HORSESHOE RIDGE SUBDIVISION 1ST AMENDMENT

LOT 2, BLOCK 1, HORSESHOE RIDGE SUBDIVISION 1ST AMENDMENT

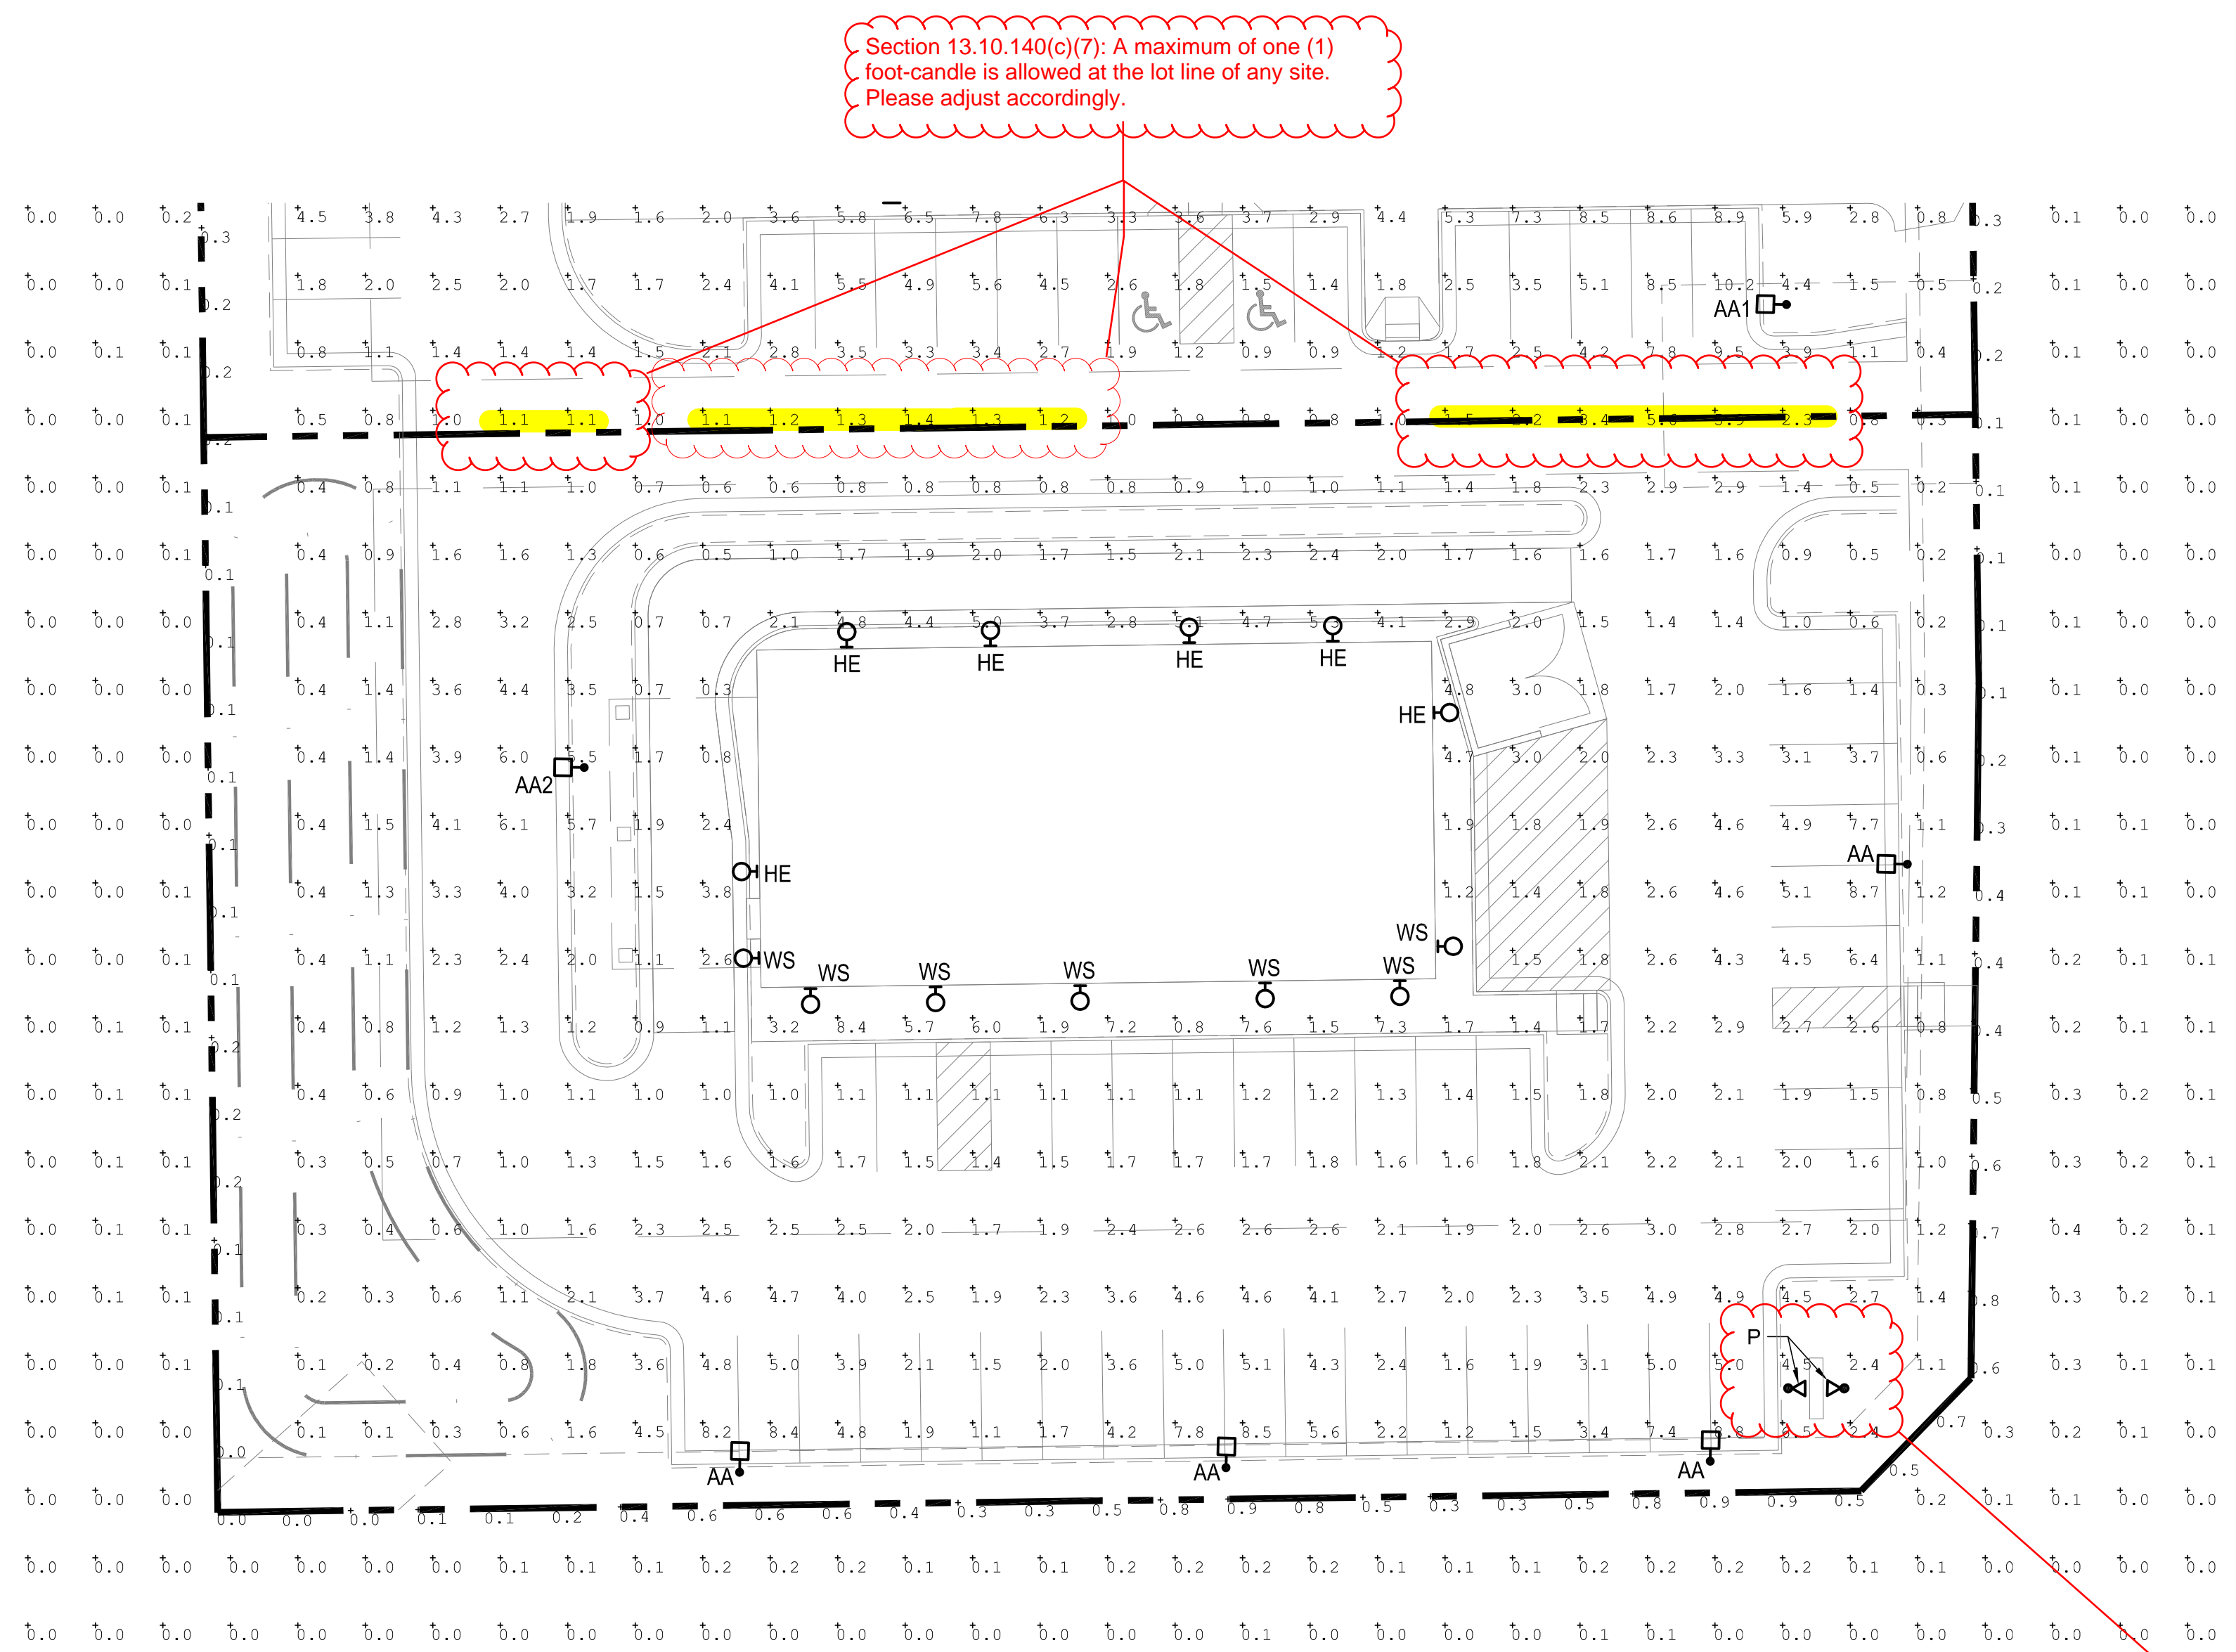
Signs are not being evaluated with this site plan review. All sign lighting will be reviewed at the time of a separate sign permit. Please add a note indicating this lighting is not being reviewed at this time but under separate permit.
